ADDENDUM NO. 1

RE: Sewer Interceptor Replacement – Camden Water Utilities, Camden, Arkansas

ADDENDUM DATE: July 13, 2022

Job No.: CM-02-19
 Scale: 1"=50'
 Date: AUG. 2021
 Sheet 9

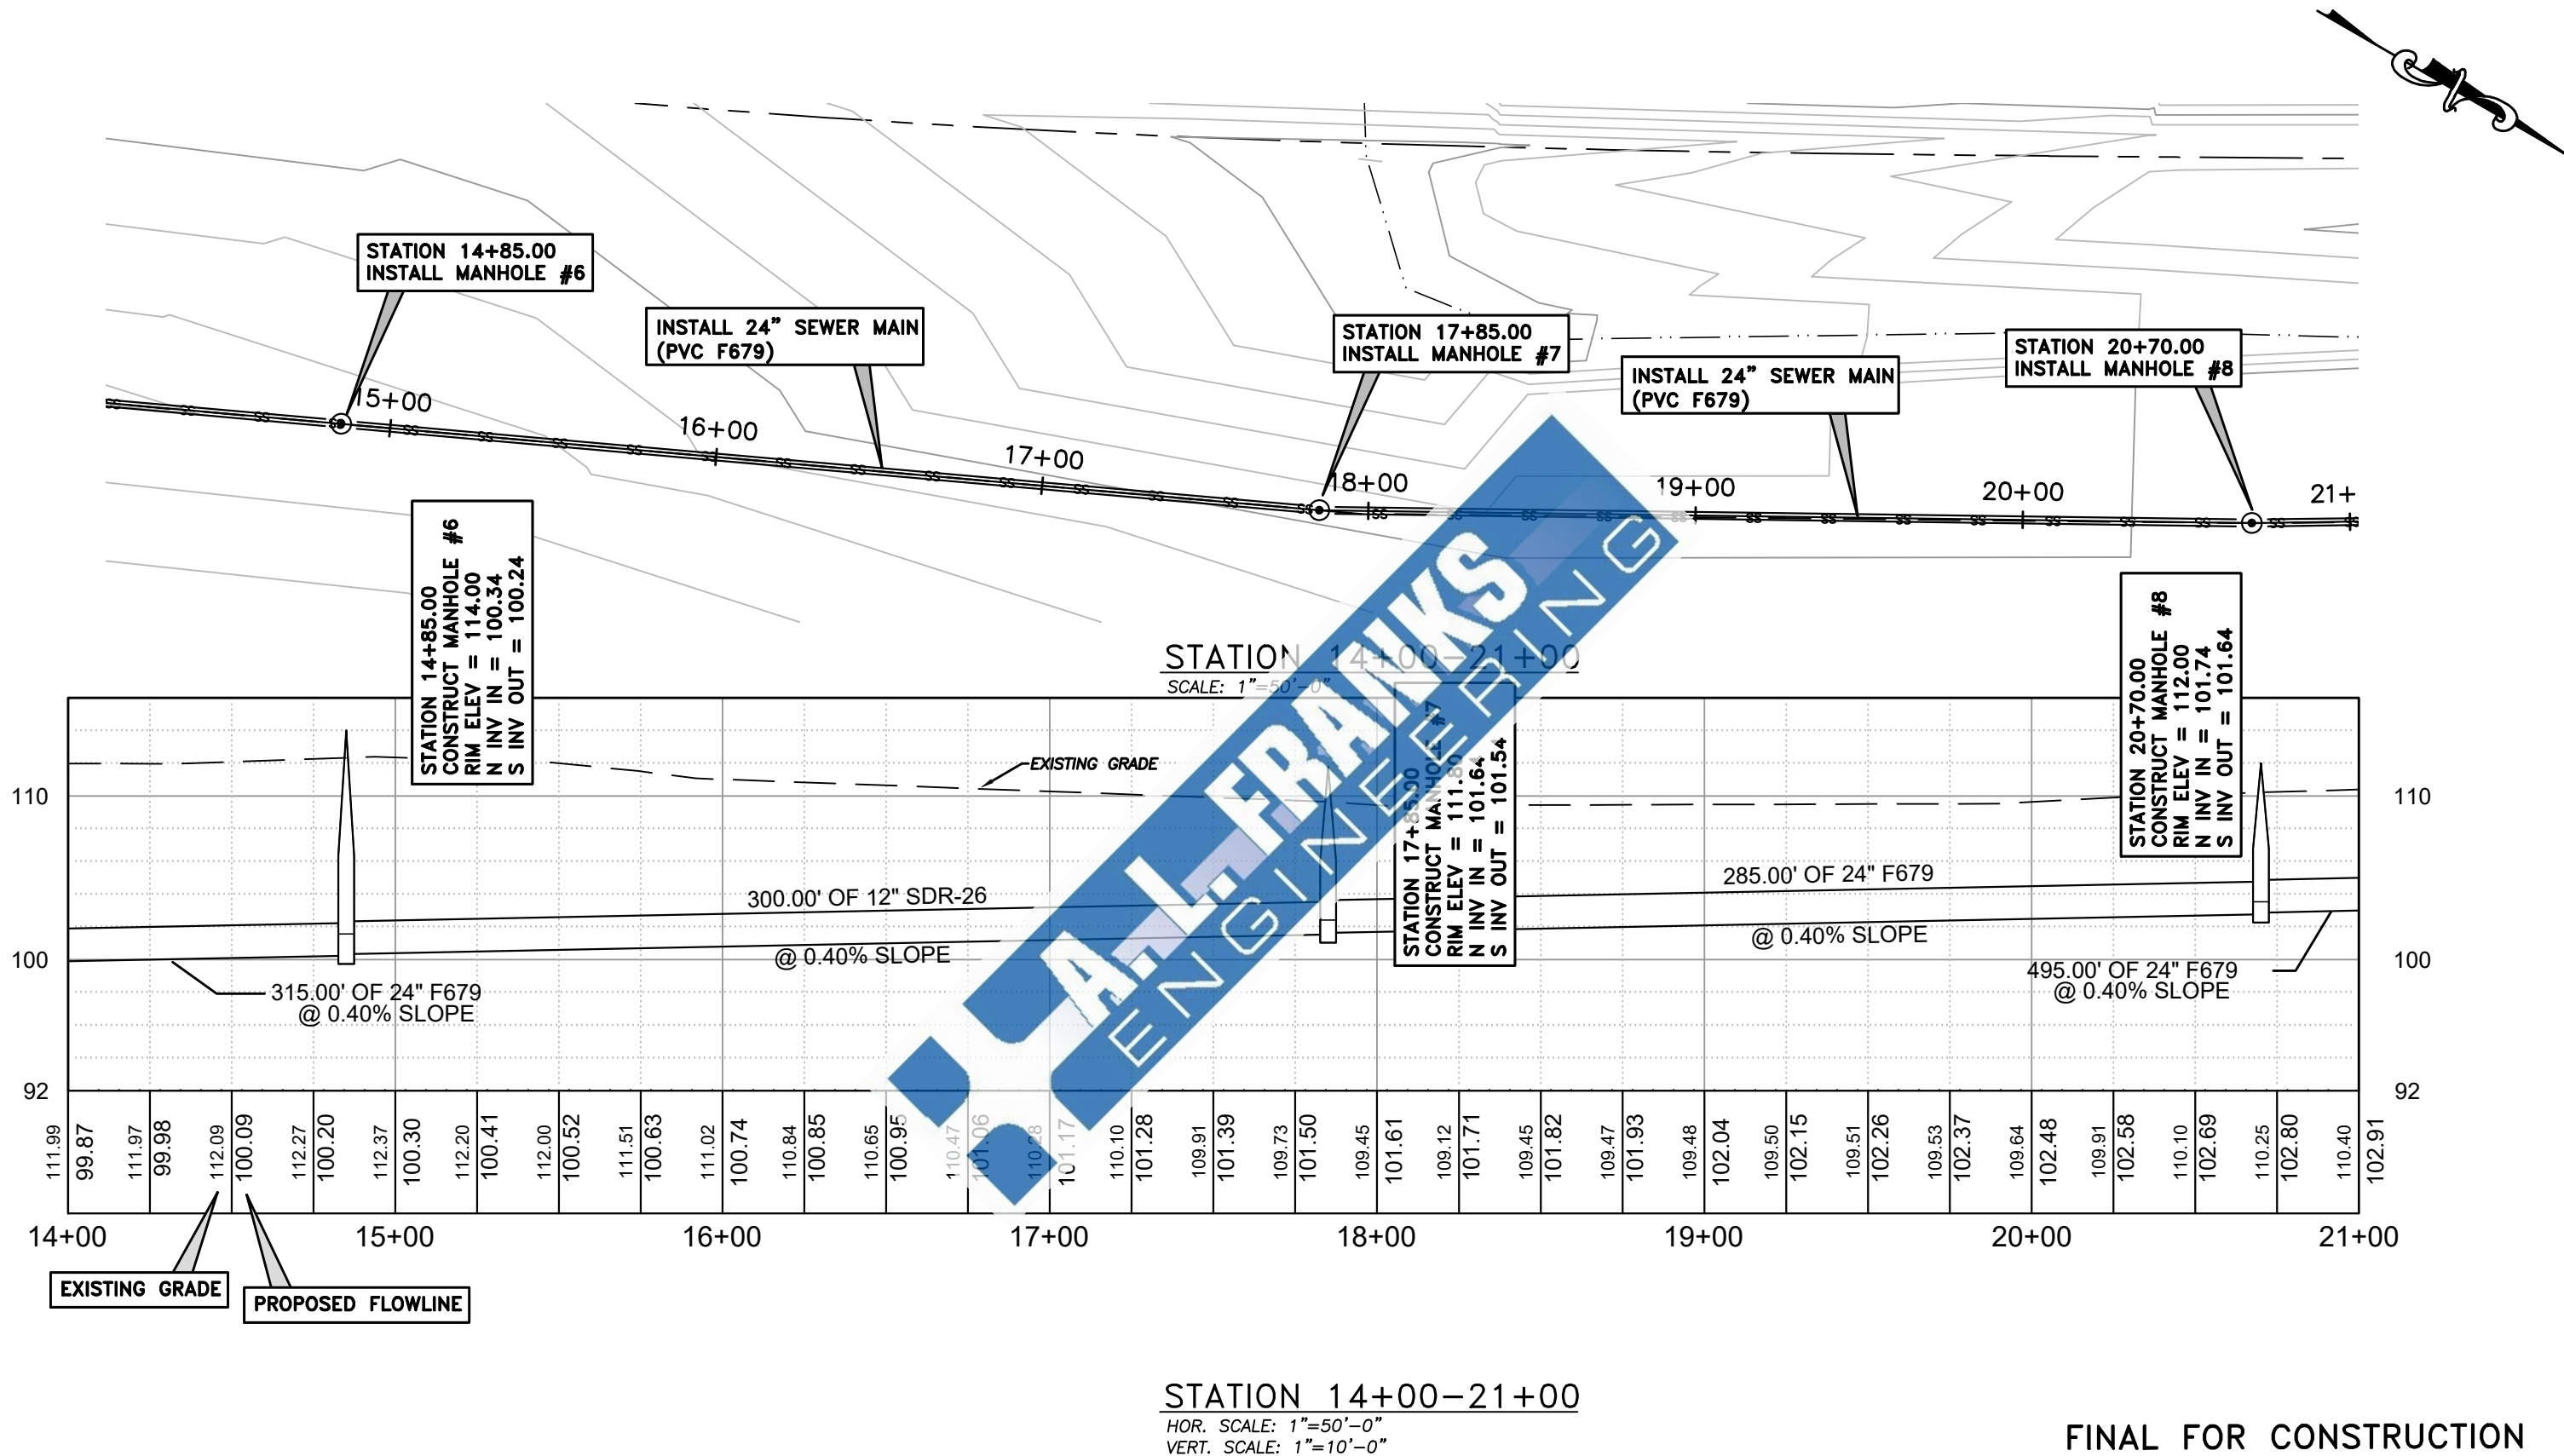
#1	7/11/22	PIPE SLOPE ADJ. / CONNECT MH 4	JCH
No.	Date	Revision	By

Job No.: CM-02-19
Scale: 1"=50'
Date: AUG. 2021
Sheet 10

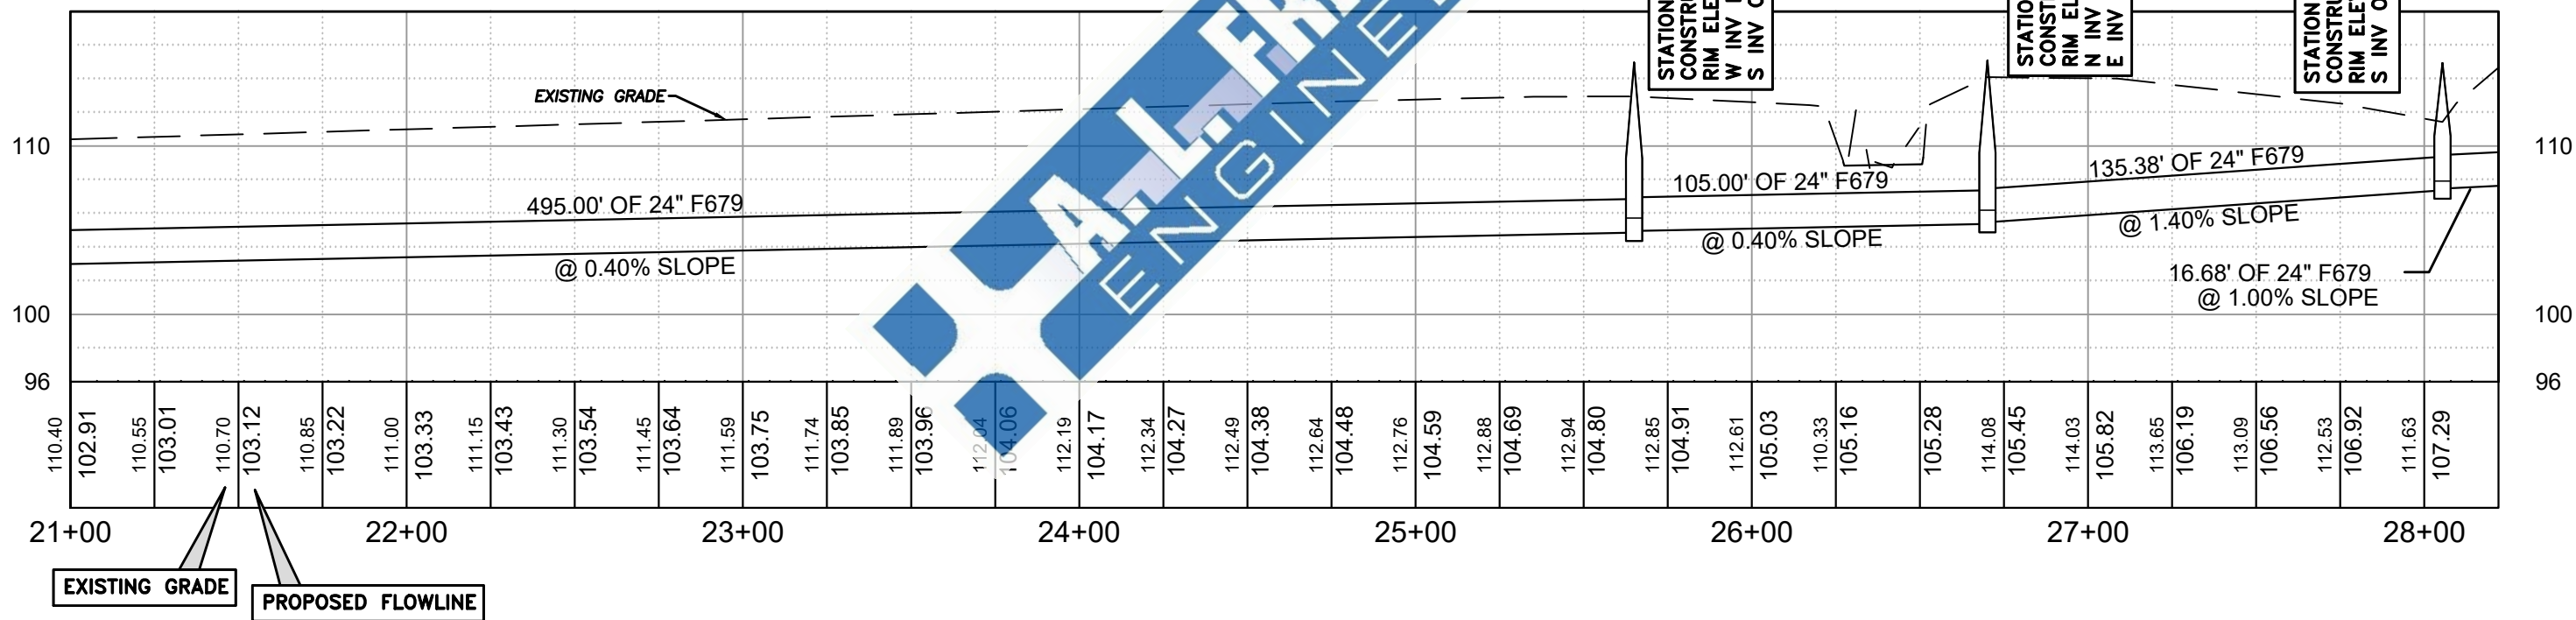
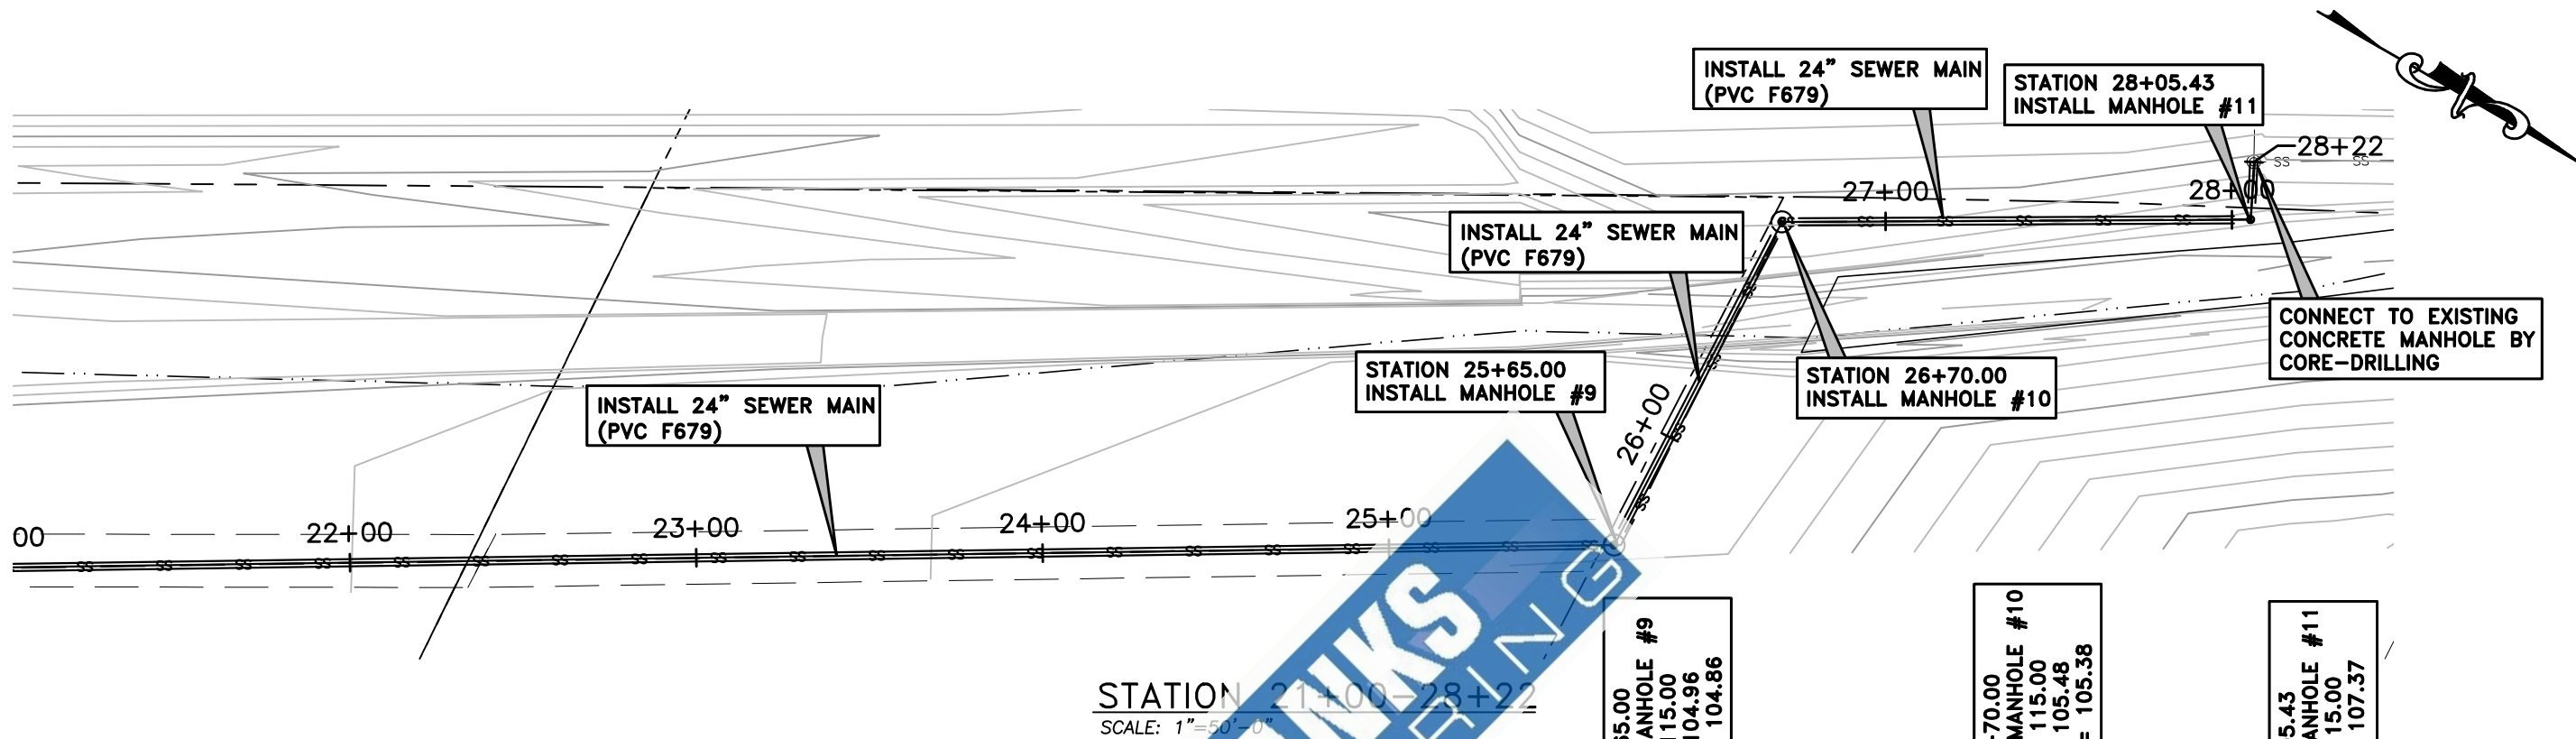
No.	Date	Revision	By
#1	7/11/22	MH #6 RIM ELEV. / PIPE SLOPE ADJ.	JCH

Job No.: CM-02-19
 Scale: 1"=50'
 Date: AUG. 2021
 Sheet 11

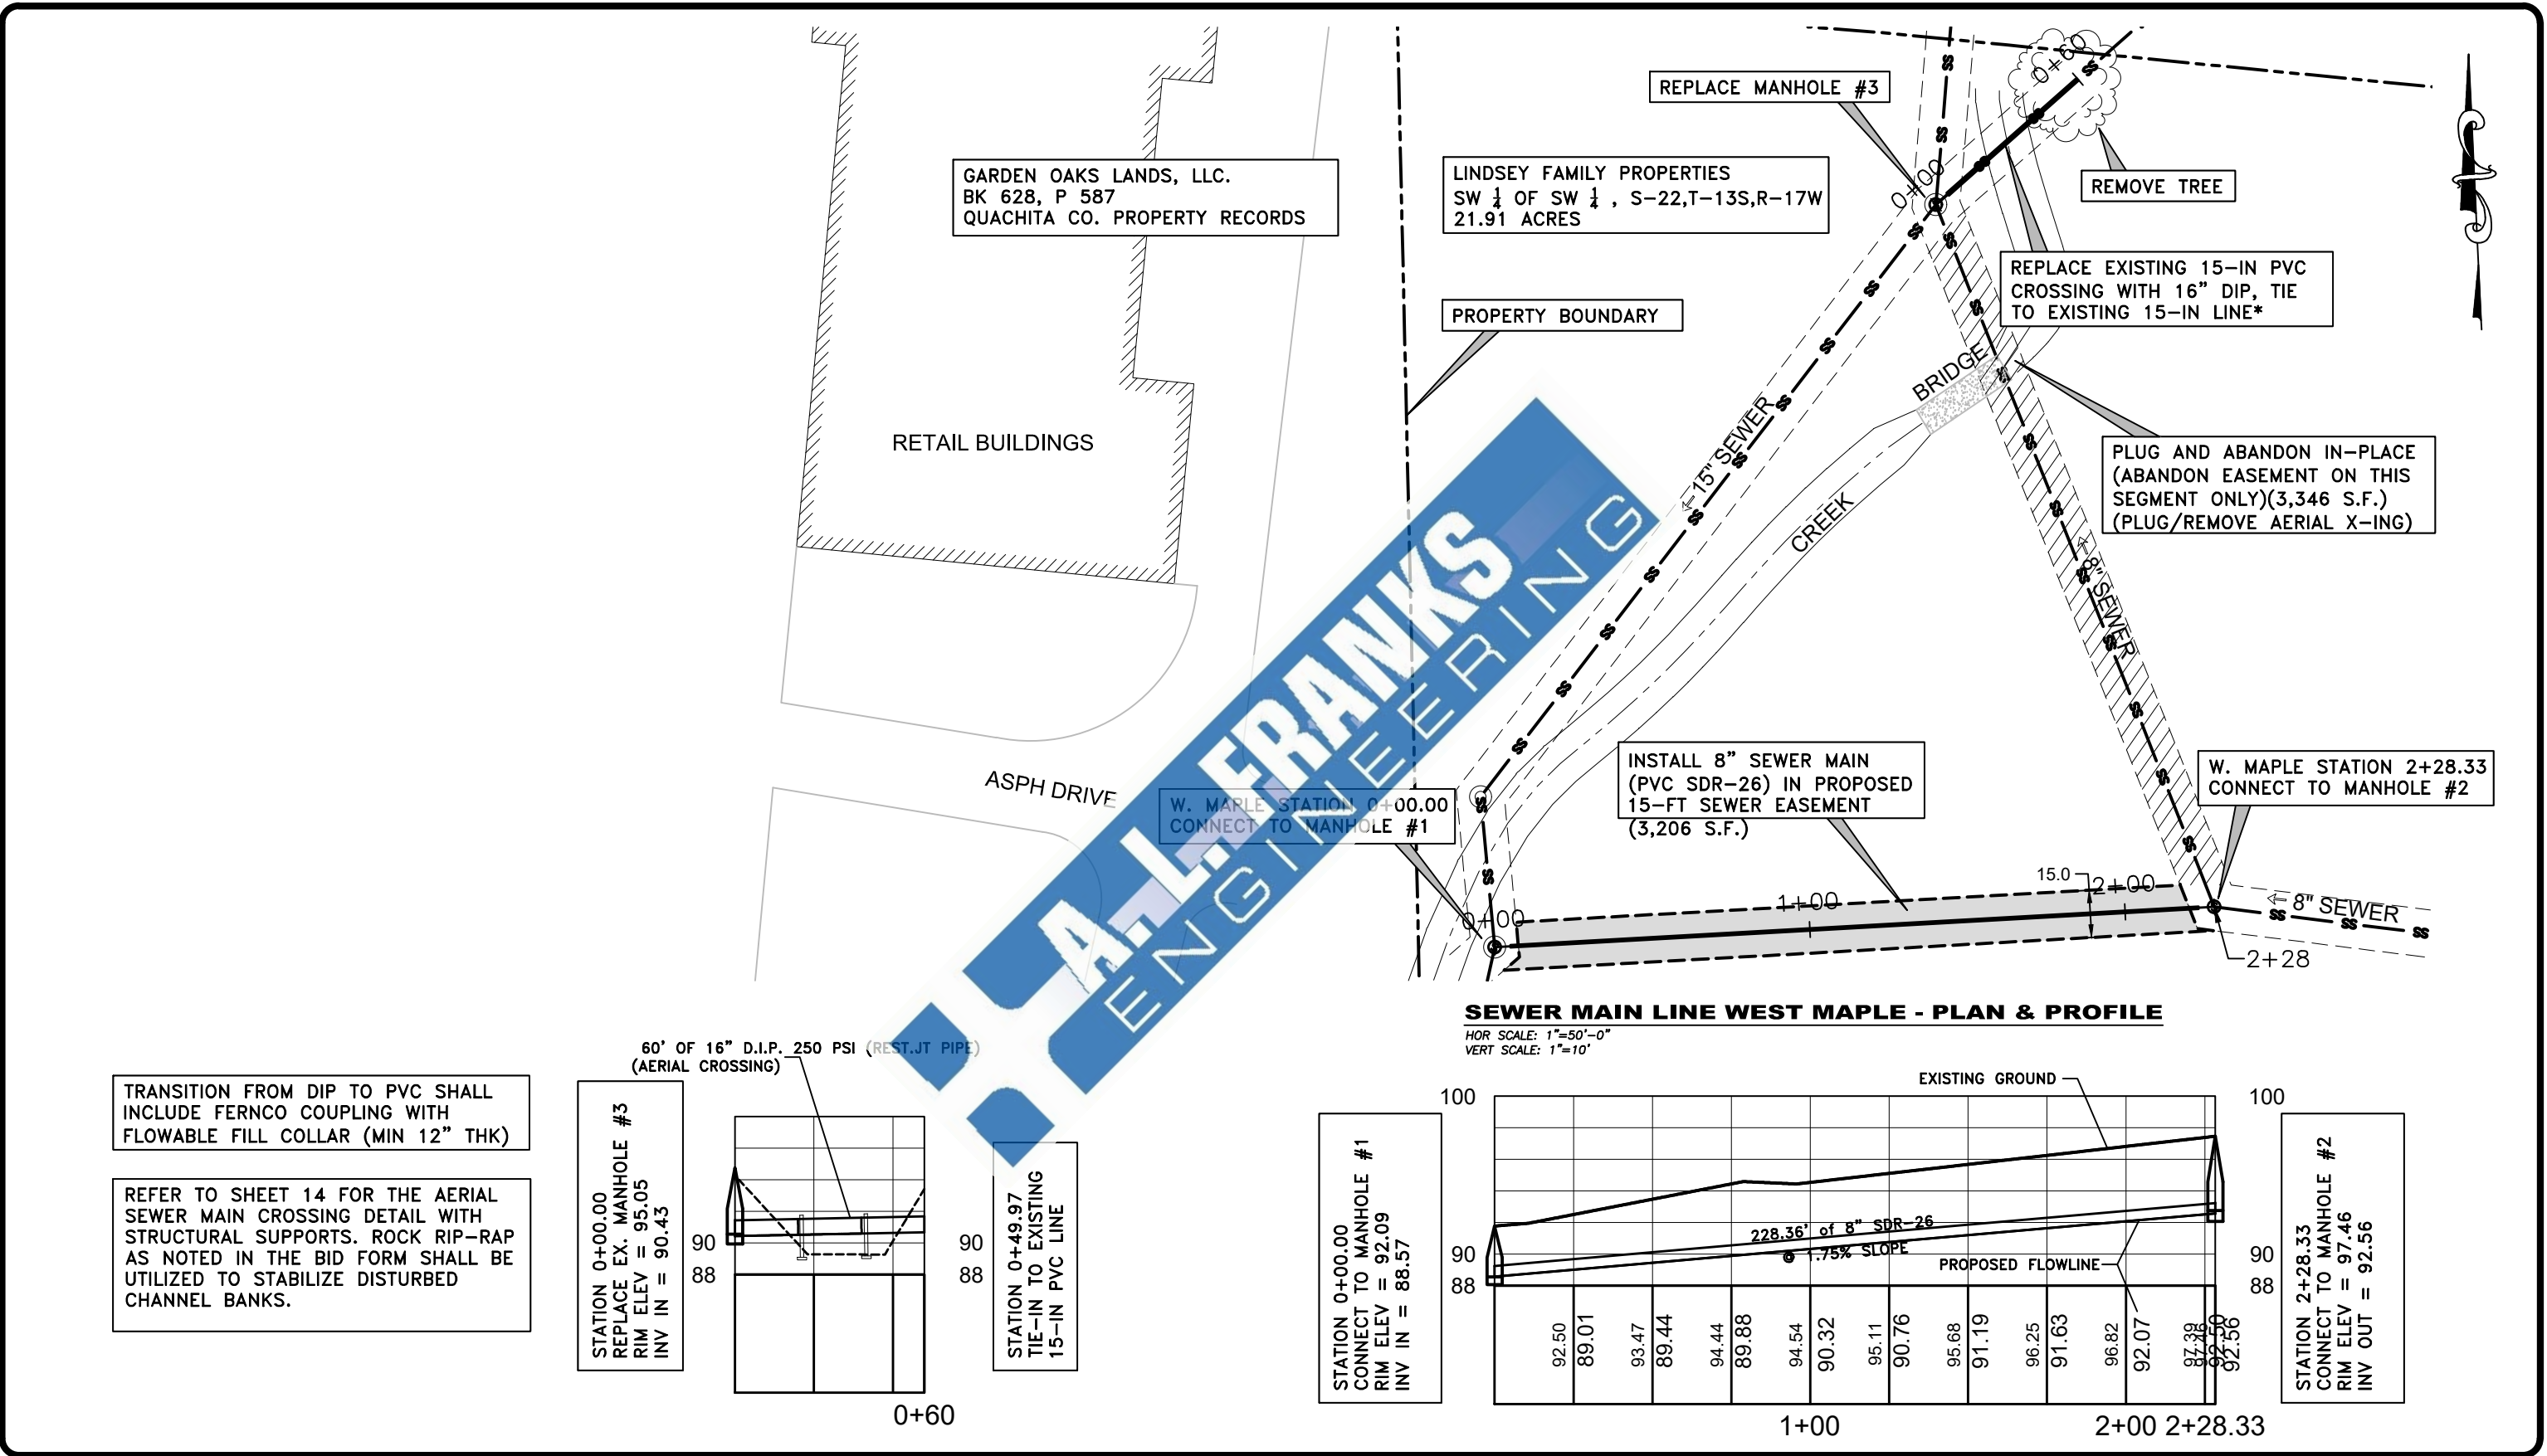
#1	7/11/22	PIPE SLOPE ADJ.	JCH
No.	Date	Revision	By
